Re: LeBreton Flats Library Parcel – 665 Albert Street, City of Ottawa
Booth Street and Albert Street NE Roadside Safety Assessment
TYLin Ref. 10399

MEMORANDUM

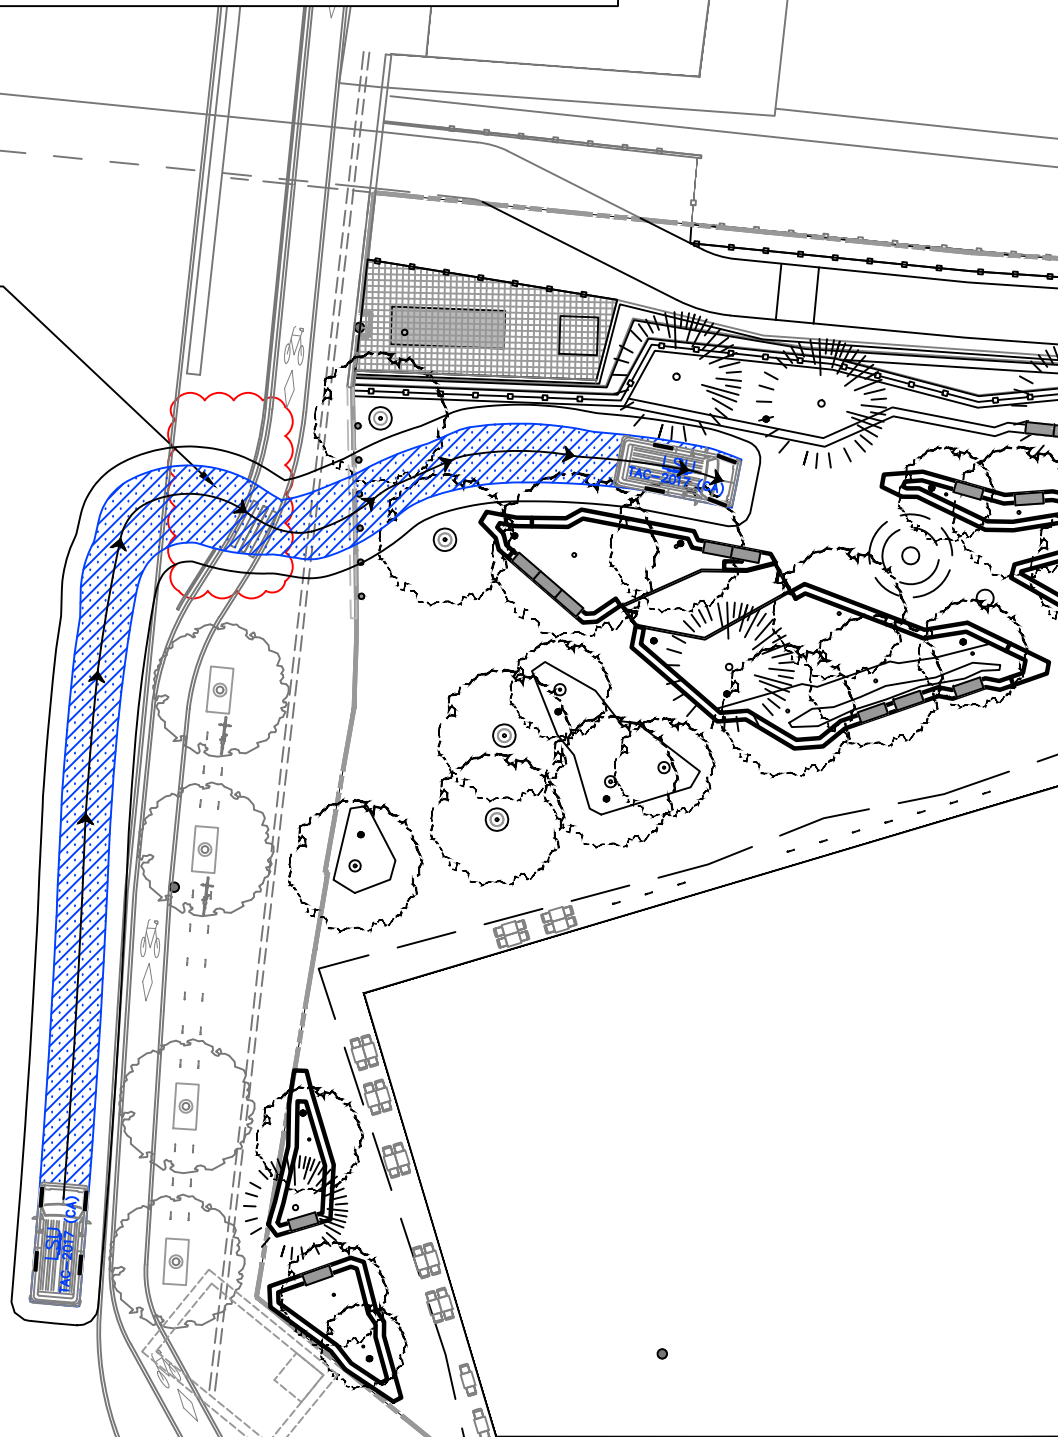
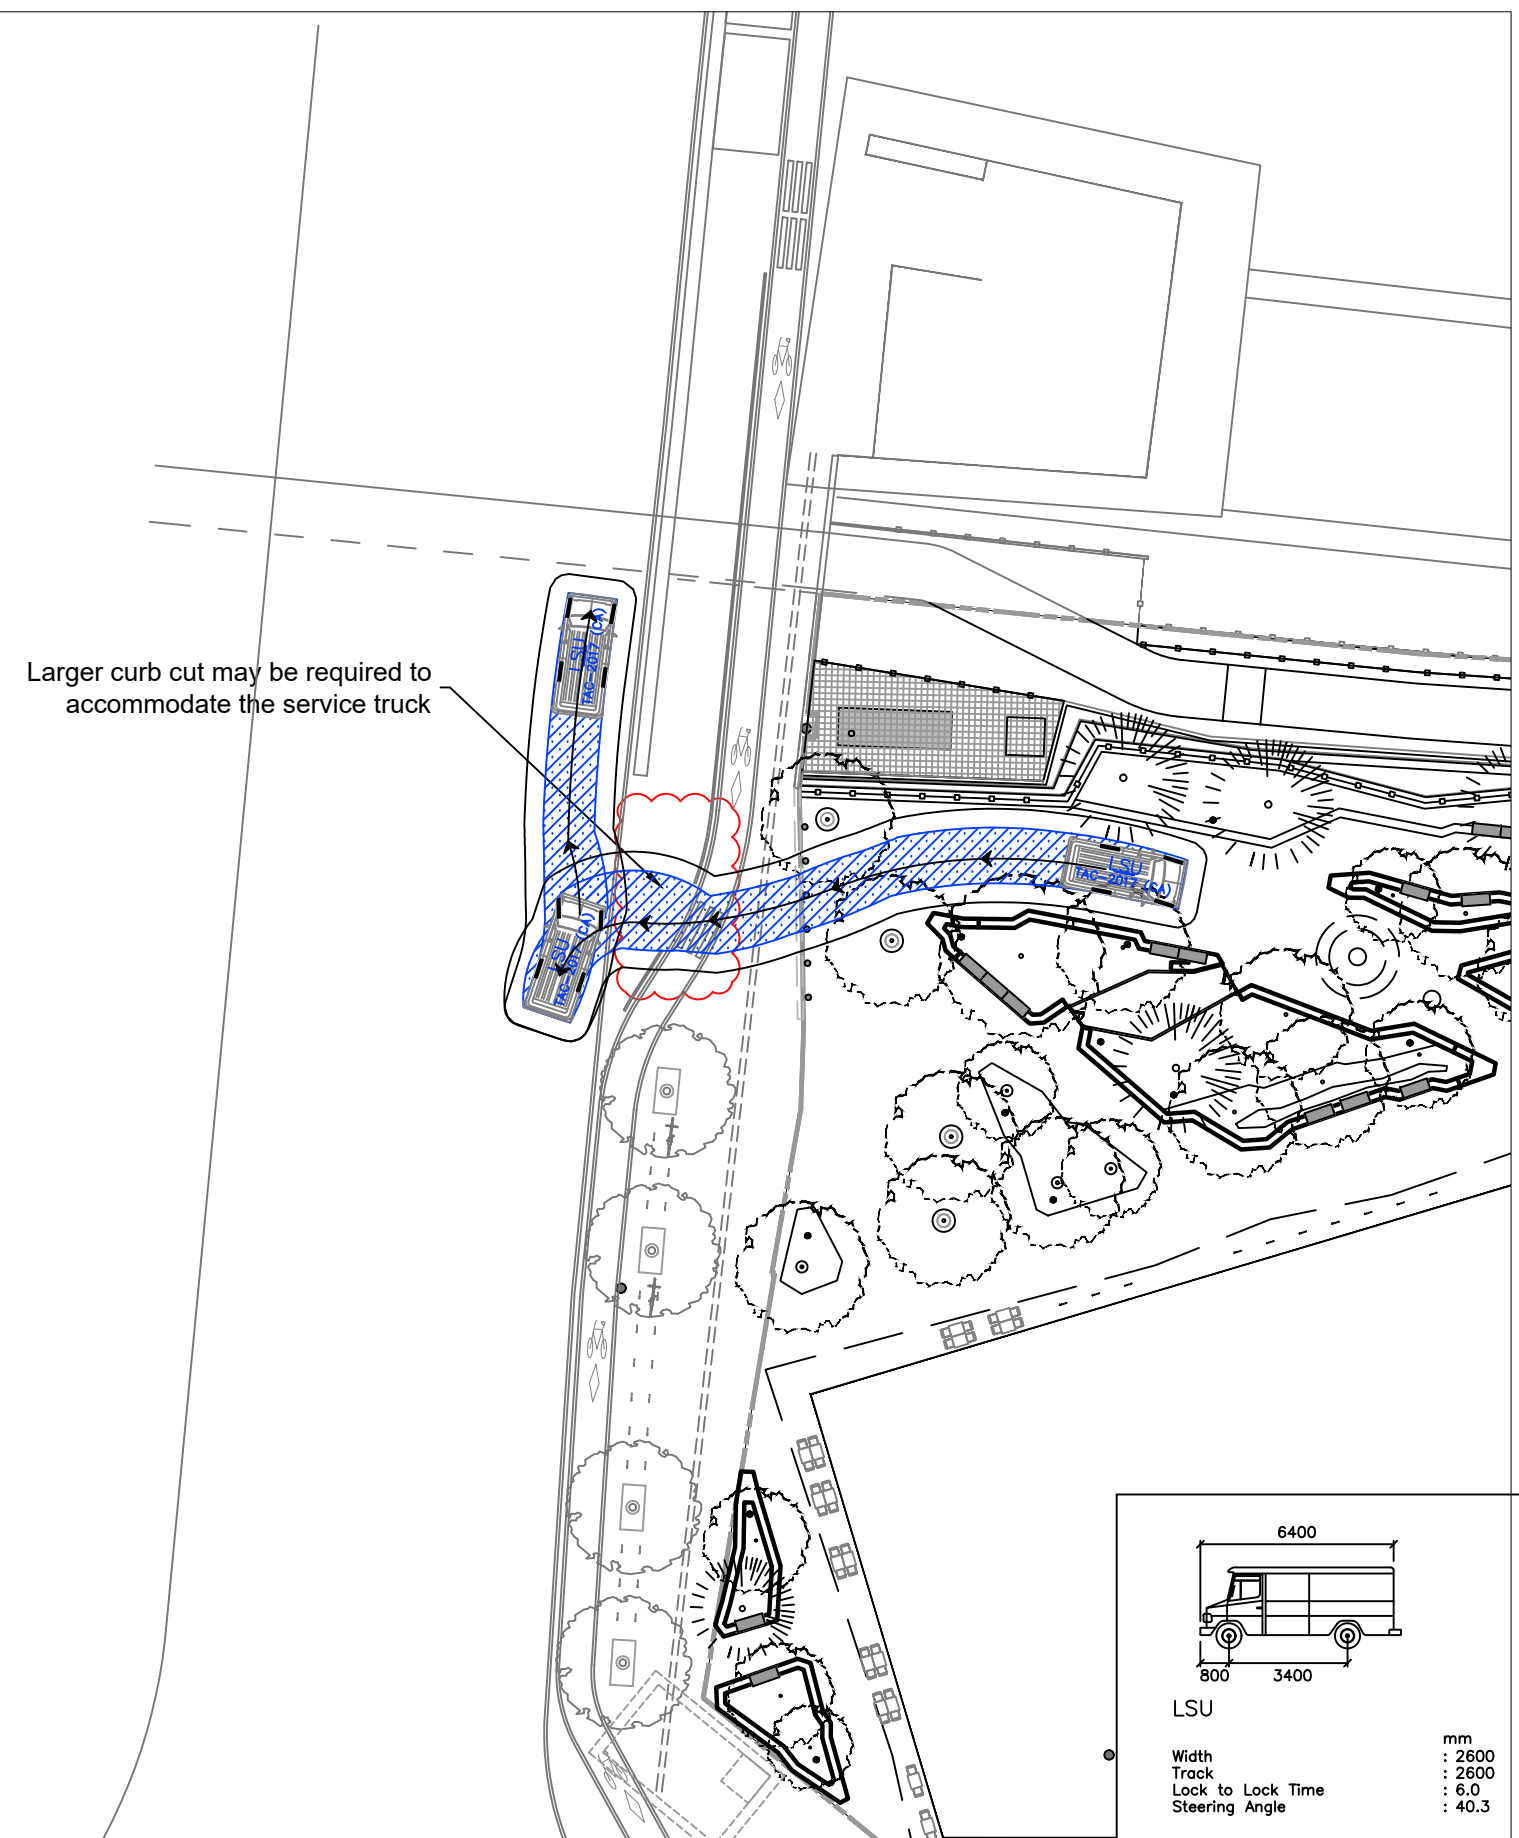
Please note that the design vehicle used for the simulation may be different than the operating vehicle. It is our understanding that two small vans will also access the site. A typical delivery truck (TAC-LSU) was used for this exercise. Please confirm with the design vehicle's dimensions and specs.

- 1.0m horizontal buffer was considered throughout the truck swept path
- It is strongly recommended that trained staffs from the city or property management staffs be present to assist circulation of the service truck. The truck will reverse in to the pedestrian realm from a public road, therefore vulnerable users shall be warned during this operation.

Larger curb cut may be required to accommodate the service truck

Larger curb cut may be required to accommodate the service truck
